UNITED STATES
NUCLEAR REGULATORY COMMISSION

SUBJECT: ISSUANCE OF AMENDMENT - MILLSTONE NUCLEAR POWER STATION, UNIT NO. 3 (TAC NOS. M98035 AND M99502)

The Commission has issued the enclosed Amendment No. 157 to Facility Operating License No. NPF-49 for the Millstone Nuclear Power Station, Unit No. 3, in response to your application dated August 29, 1997, as supplemented by letters dated September 25 and November 14, 1997.

Based on a review and subsequent calculations of the cold overpressurization protection (COPS) enabling temperature and the emergency core cooling system (ECCS)/charging system mode 3 requirements, Northeast Nuclear Energy Company (NNECO) proposes to reduce the COPS enabling temperature. As a result, NNECO proposed the following Technical Specifications (TS) changes: add new heatup and cooldown pressure/temperature limit curves and their associated requirements; add new power operated relief valve (PORV) setpoint curves and their associated requirements; revise the reactor coolant loops and coolant circulation, ECCS, boration systems, and COPS to incorporate the lower enabling temperature and new restrictions for cold overpressure protection system, PORV undersh

FIGURE 3.4-2

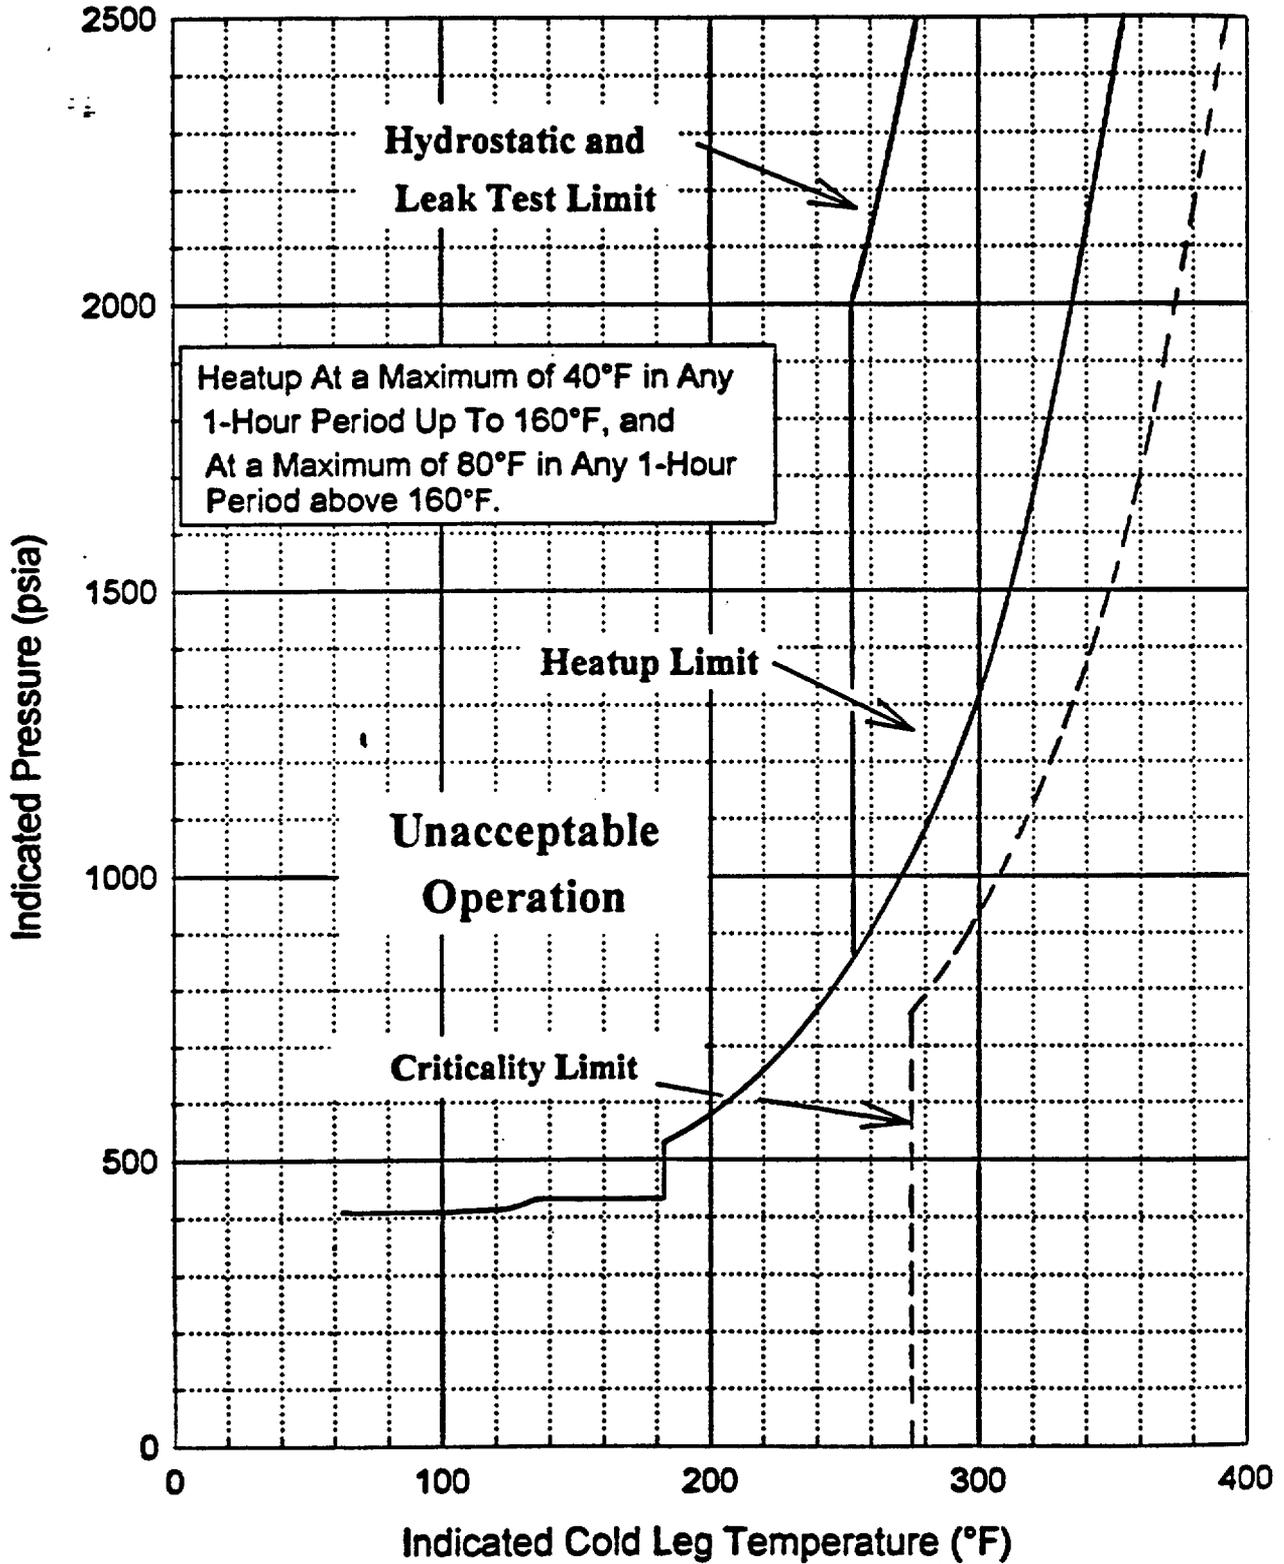
- a. During an RCS heatup, the heatup limits of Figure 3.4-2 apply with the additional restriction that only one reactor coolant pump can be operating when the lowest unisolated RCS loop wide range cold leg temperature is $\leq 160^{\circ}\text{F}$.

The LCO and Figures 3.4-2 and 3.4-3 contain P/T limit curves for heatup, cooldown, inservice leak and hydrostatic (ISLH) testing, and data for the maximum rate of change of reactor coolant temperature.

The ARTs calculated by the staff and the licensee are almost identical. However, substituting the ART of 111.9 °F into equations in SRP 5.3.2, the staff could not verify the proposed P-T limit curves. In its response to the staff's request, the licensee, in a letter dated September 25, 1997, provided details of the methodology used. This information revealed that Millstone Unit 3 has some unique features built into the P-T limits: (1) the proposed P-T limits considered indicator uncertainties, 22 °F for temperature and 129 psia for pressure; (2) it considered a pressure drop of 28.3 psi between the pressure transmitter and the reactor vessel beltline for one pump operation and a pressure drop of 74 psi for four pump operation; (3) the cooldown curve is made of the conservative portions of the P-T limits at a cooldown rate of 0 °F/hr and the P-T limits at a cooldown rate of 80 °F/hr to 160 °F and 40 °F/hr to 60 °F; and (4) the pressure was expressed in "psia," with a value of 10 added to the gage pressure to account for the primary containment pressure. After considering the extra conservatism in (1) (2), and (3), the staff confirmed the proposed P-T limits (for 10 EFPY) for heatup, cooldown, and hydrotest and concluded that they meet the beltline material requirements in Appendix G of 10 CFR Part 50. The staff found that all equations involving the conversion of the pressure in psig to psia in Reference 2 had a sign error. However, from the intermediate results presented, the staff verified that the correct sign was used in actual calculations.

Figure 3.4-3

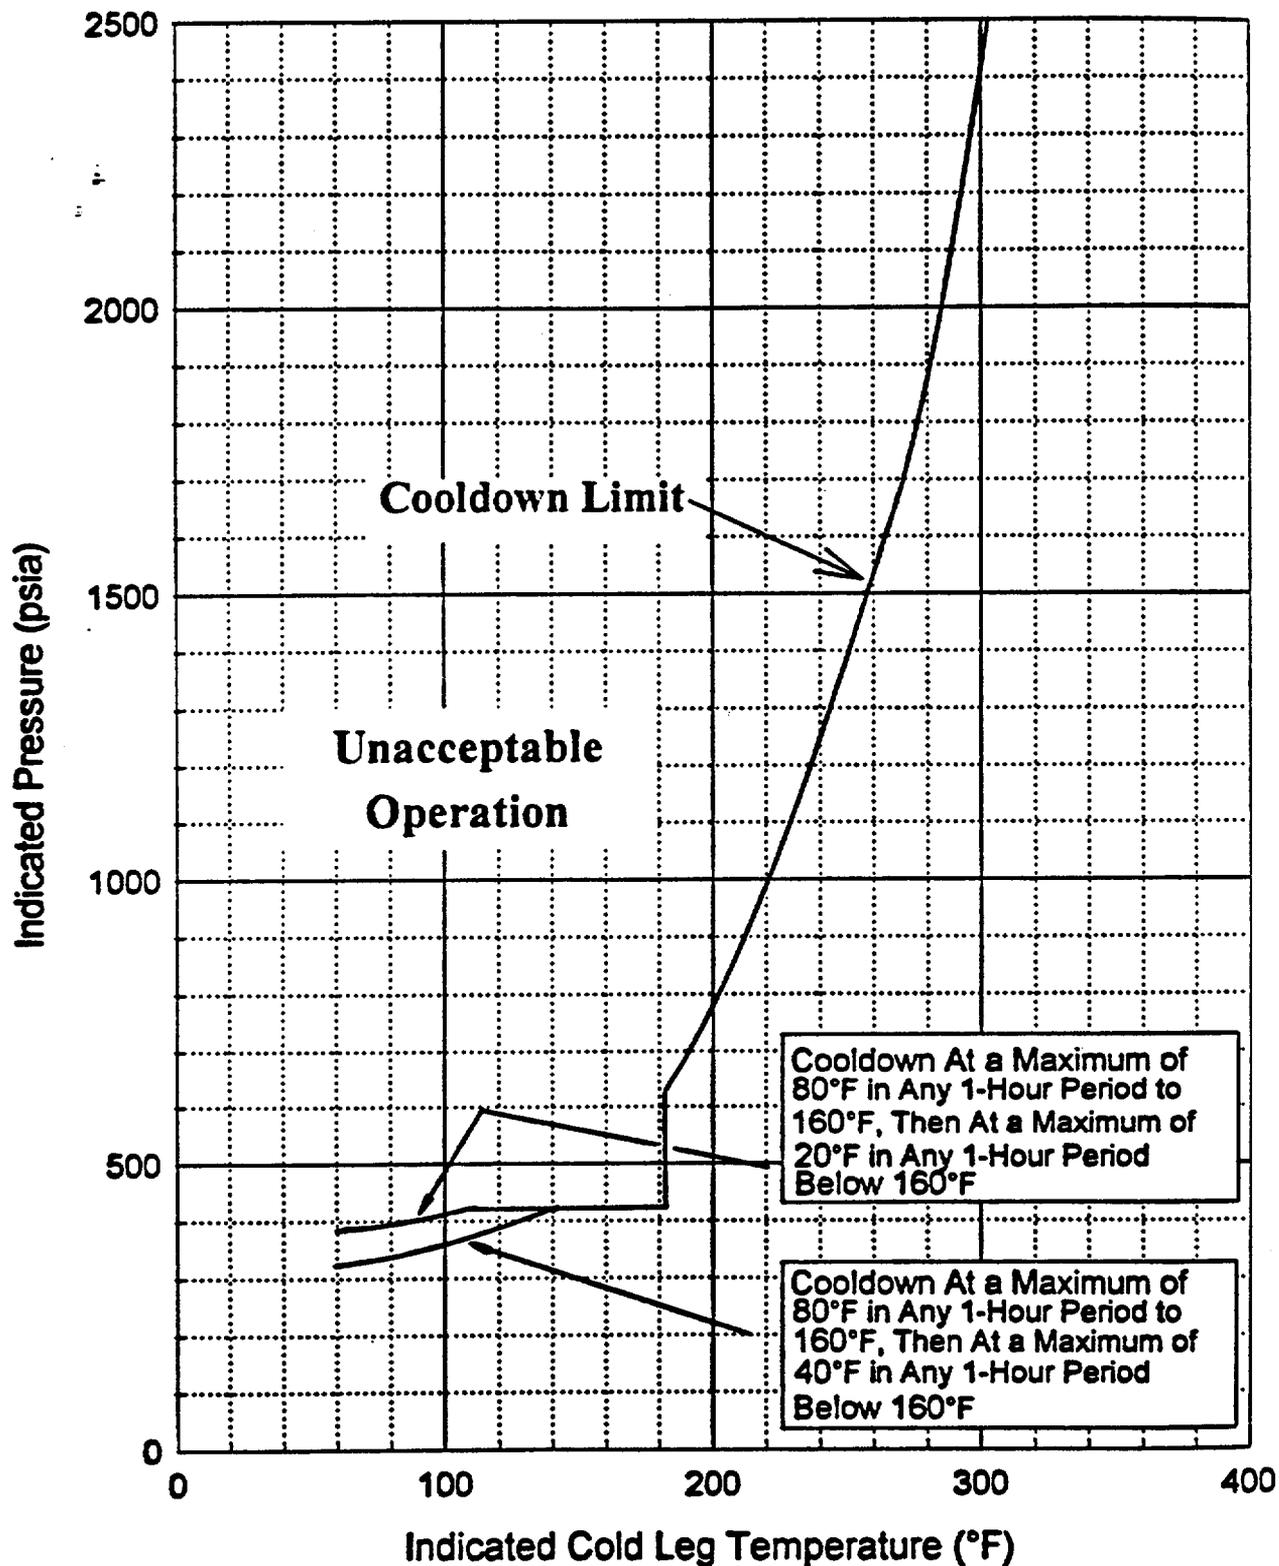
- b. During an RCS cooldown, the limits of Figure 3.4-3 apply with the additional restriction that only one reactor coolant pump can be operating when the lowest unisolated RCS loop wide range cold leg temperature is $\leq 160^{\circ}\text{F}$ and no reactor coolant pump may be operated when the lowest unisolated RCS loop wide range cold leg temperature is $\leq 120^{\circ}\text{F}$.

FIGURE 3.4-4a

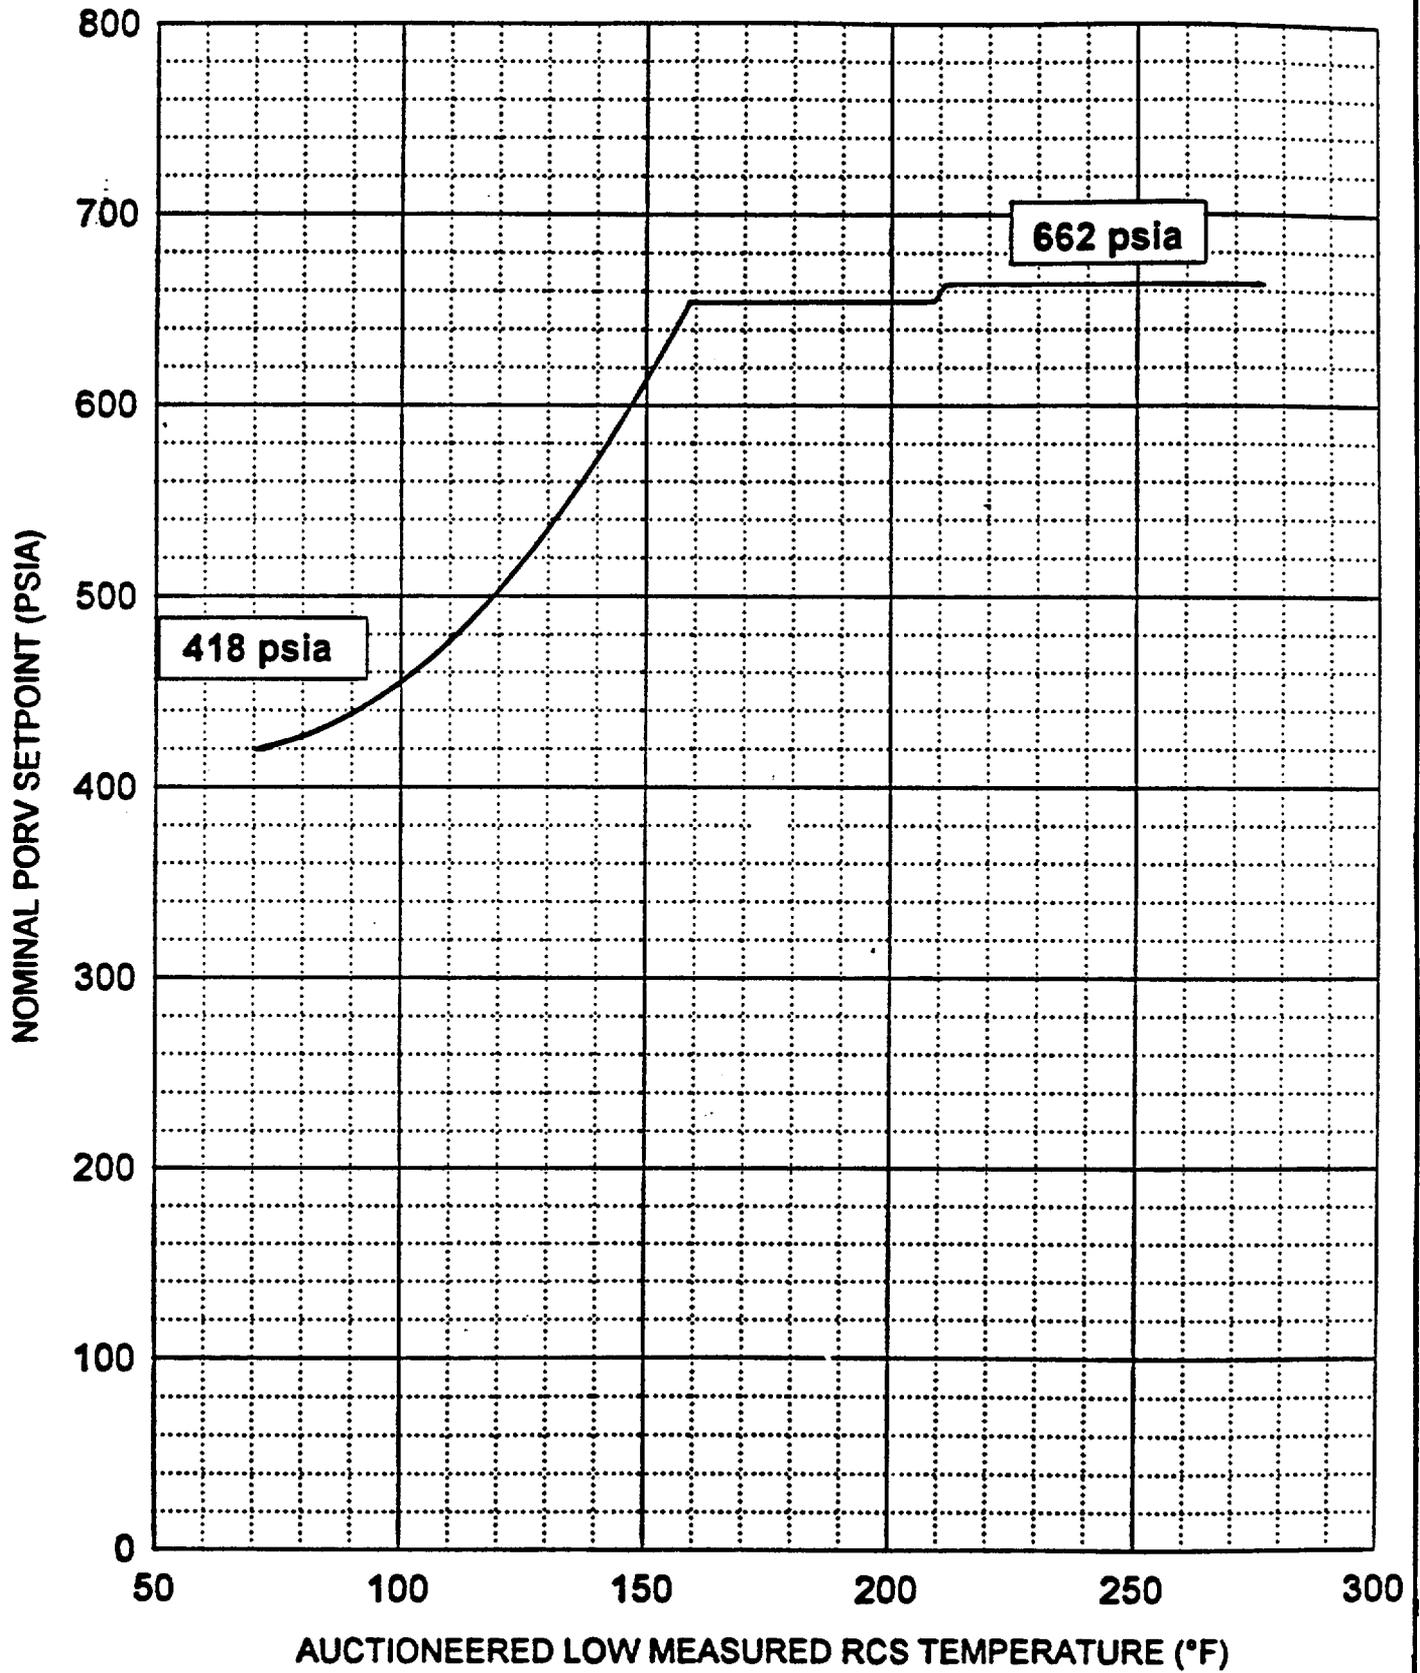
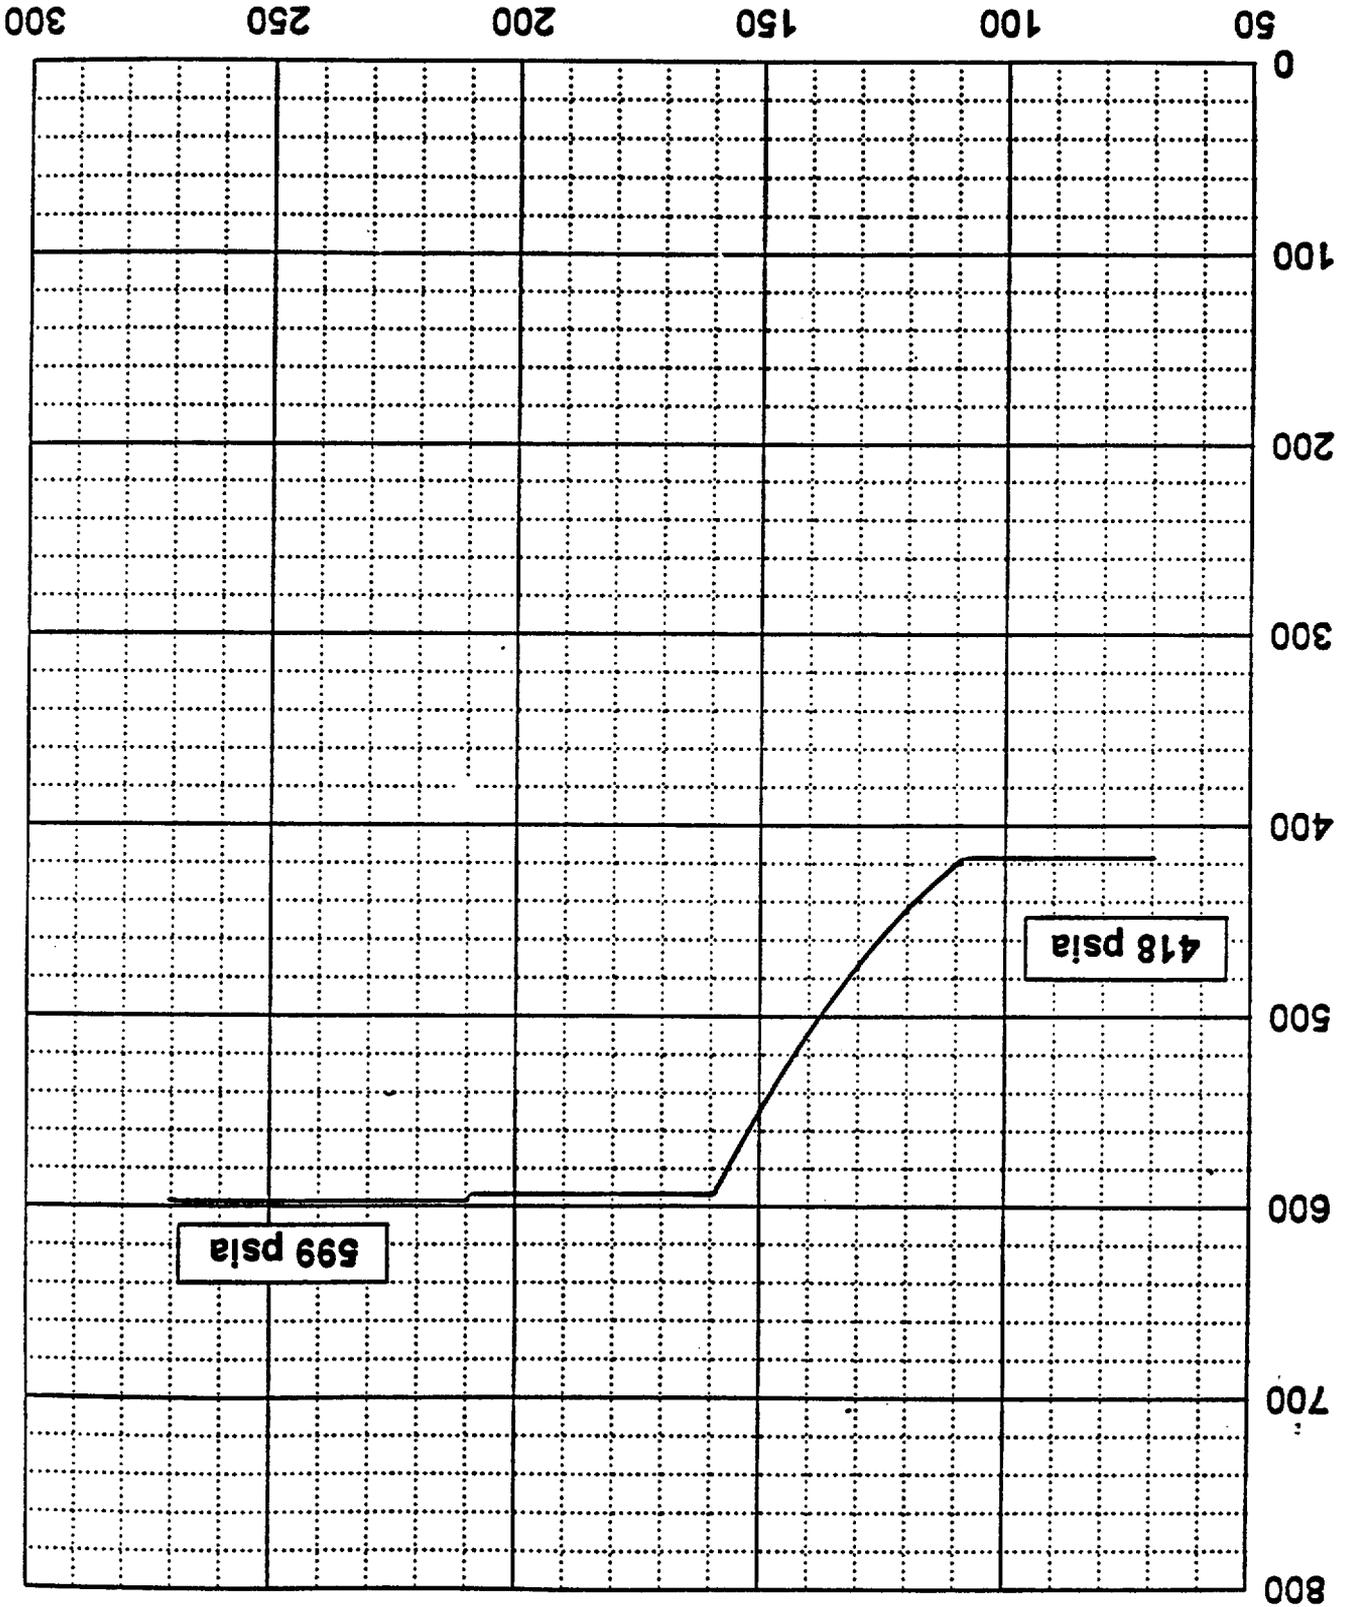
Figure 3.4-4a and Figure 3.4-4b present the PORV setpoints for COPPS. Above 110°F, the setpoints are staggered so only one valve opens during a low

temperature overpressure transient. Setting both valves to the values of Figure 3.4-4a and Figure 3.4-4b within the tolerance allowed for the calibration accuracy, ensures that the Reference 1 limits will not be exceeded for the analyzed isothermal events.

The 10CFR50 Appendix G analyses show that the vessel is protected against non-ductile failure when the PORVs are set to open at the values shown in Figures 3.4-4a and 3.4-4b within the tolerance allowed for the calibration accuracy. The curves are derived by analyses that model the performance of the PORV cold overpressure protection system (COPPS), assuming the limiting mass and heat transients of one centrifugal charging pump injecting into the RCS, or the energy addition as a result of starting an RCP with temperature asymmetry between the RCS and the steam generators. These analyses consider pressure overshoot and undershoot beyond the PORV opening and closing, resulting from signal processing and valve stroke times.

The licensee proposed PORV actuation setpoints in TS Figures 3.4-4a and 3.4-4b were calculated in accordance with the proposed methodology. In response to the staff request, the licensee, in its letter dated November 14, 1997, provided a tabulation to list PORV setpoint, transient pressure overshoot, instrumentation uncertainties for temperature and pressure and corresponding P-T limit under various temperature conditions below the COPS enable temperature. The data presented in this tabulation confirms that the proposed PORV setpoints will provide adequate protection to the 10 CFR Part 50, Appendix G, P-T limits under steady state conditions during a design basis overpressure transient (mass-addition or heat-addition) as described in Section 3.1 of this safety evaluation. Based on the preceding discussion, the staff finds the proposed PORV setpoint acceptable.
